MESSENGER III / 300 PRINTED CIRCUIT BOARD

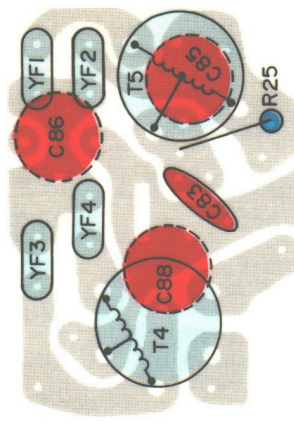
* L4 IS REPLACED BY CRYSTAL FILTER IN MESSENGER 300. SEE CRYSTAL FILTER PRINTED CIRCUIT BOARD.

** C79 HAS BEEN DELETED ON LATE MODELS OF MESSENGER III AND 300 TO IMPROVE TUNING. A .390PF FIXED MICA CAPACITOR REPLACES C79. SEE PARTS LIST.
